DESIGN REVIEW & PRESERVATION BOARD

LOCATION: 710 Kesner Avenue

PROPOSAL: House Move of a single family residence

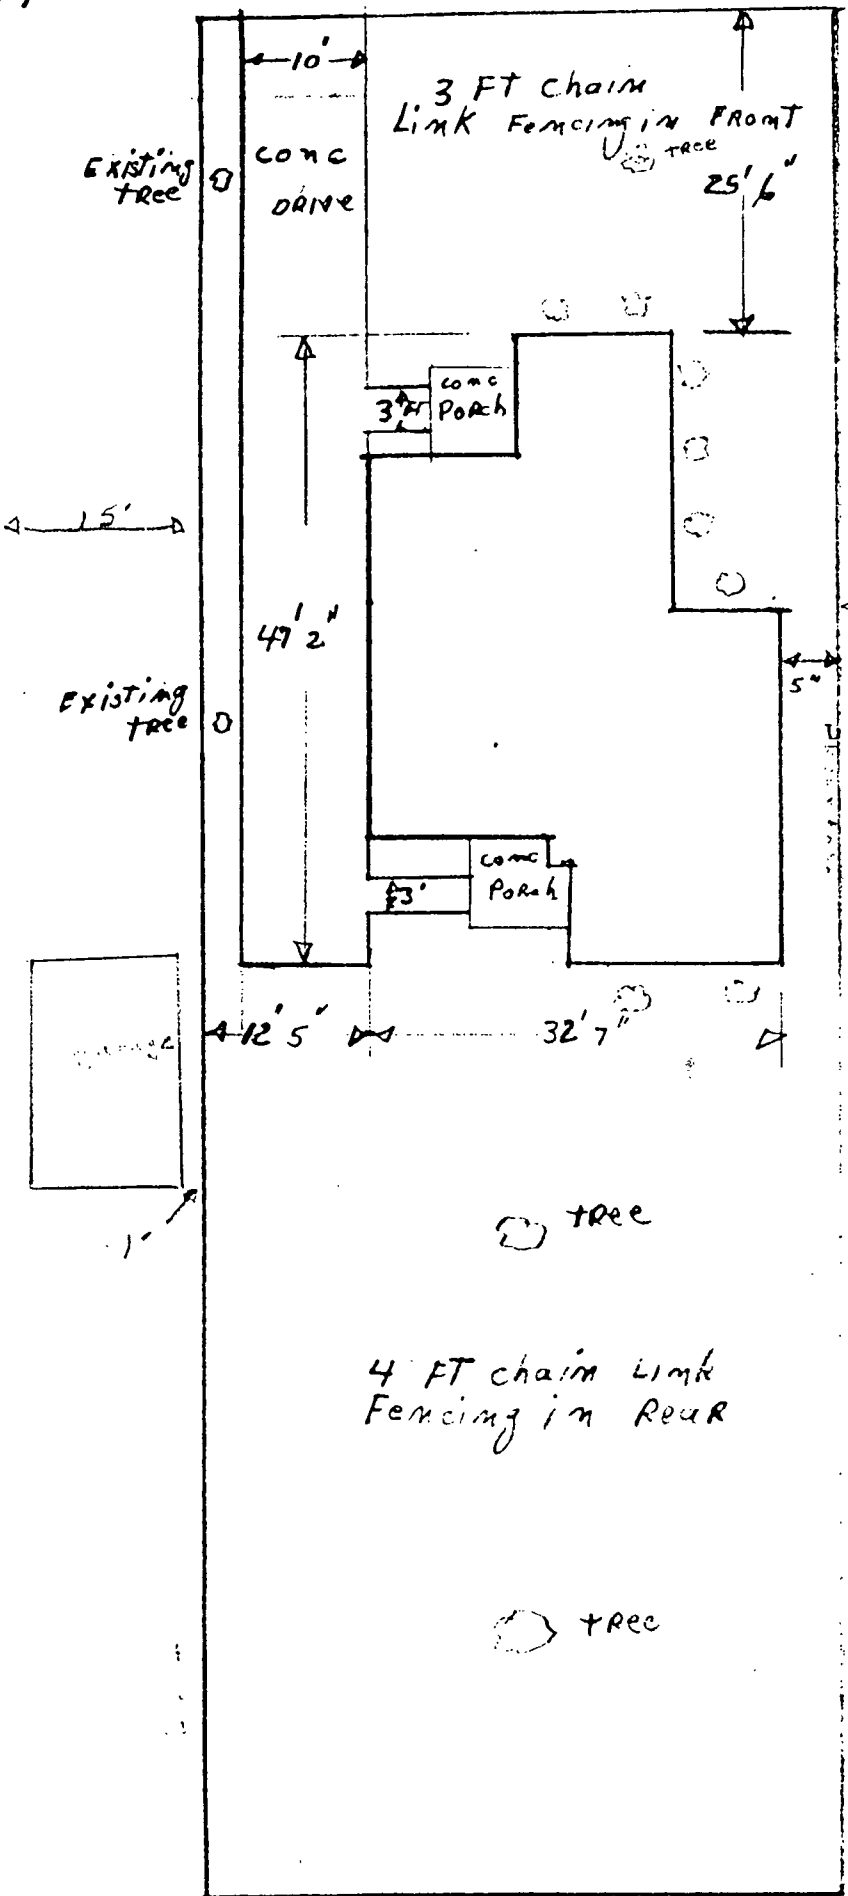
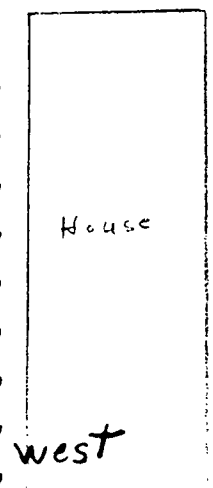
1. No covered parking is proposed in conjunction with this project. In accordance with Zoning Ordinance Sec. 2-E-26-i development of this property must include a garage due to the prevalence of garages (over 50-percent) of single family residences within 1,000 feet) in the neighborhood.
2. The applicant proposes to fence the rear property line with chainlink. Existing chainlink fencing along east property line is in good condition. Existing wire fencing along west property line is in disrepair.

1. A garage shall be provided onsite. If a suitable garage structure can be found for relocation to this property such move shall be reviewed by City staff without further consideration by the Board.
2. Chainlink fencing shall be provided along the westerly and southerly property lines.
3. Applicant will correct the deficiencies as noted on the attached preinspection worksheet.

FLOOR PLAN

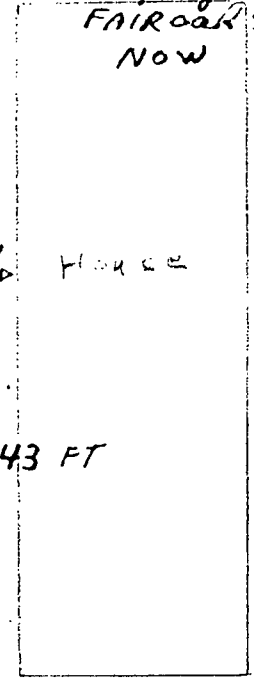
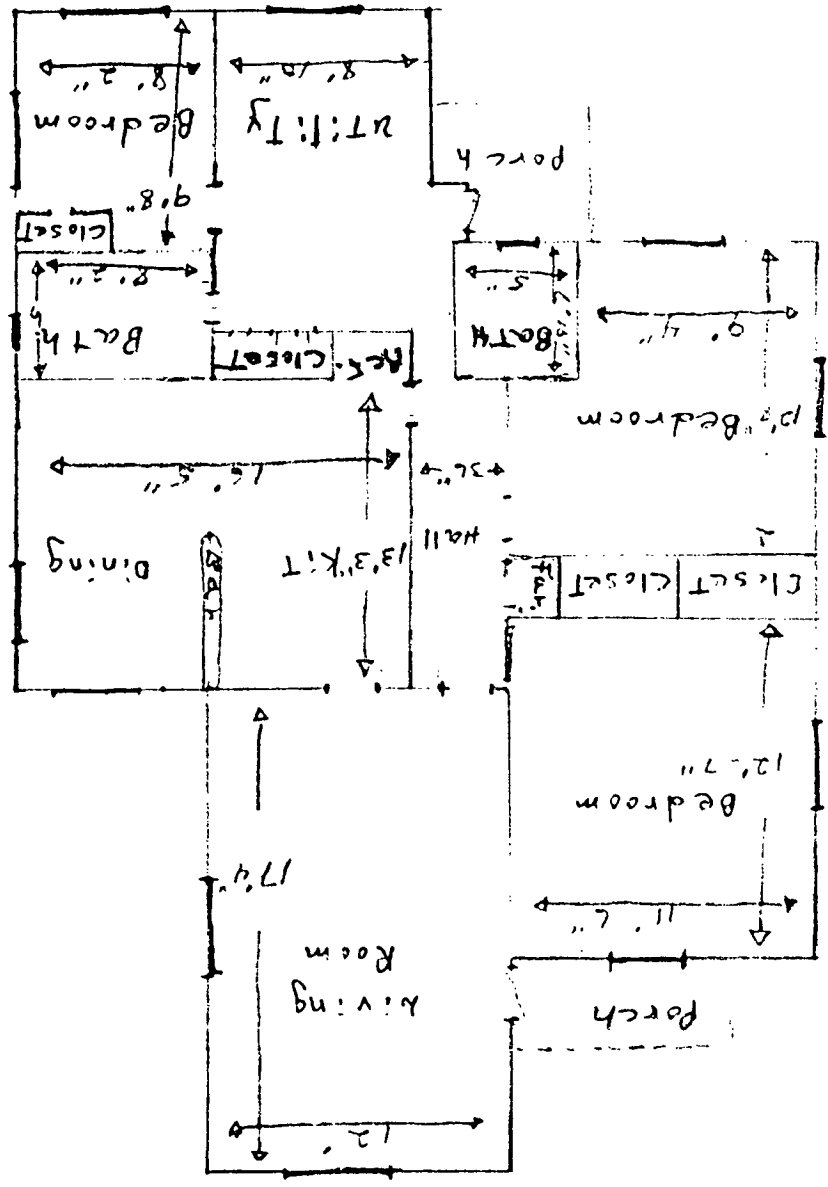
- BUILDING CODE REQUIREMENTS: ① Requires new Roof -
- ② Repair all exterior wall & paint
  - ③ Window Bed Room to meet Min Code UBC -1404)
  - ④ all wall to be repair inside
  - ⑤ Provide 20' off street Parking at new site.

- PLUMBING/MECHANICAL CODE REQUIREMENTS: ① all plumbing to meet Min Code
- ② Bath Room to meet Min Code
  - ③ all mech. to meet Min Code Heat Dwgly 20° - 3 feet off floor -
  - ④ replace H W H. ~~And~~ Vent properly -

- ELECTRICAL CODE REQUIREMENTS: ① all Exposed wire Under Dwgly - to meet Min Code
- Provide - new service
- 2 appliance Cir
  - 1 Laundry Cir
  - Spic in Bath + one Receptacle Exterior
  - all Electrical interior to meet Min Code
  - Sub panel missing Replace or wire to main Panel.
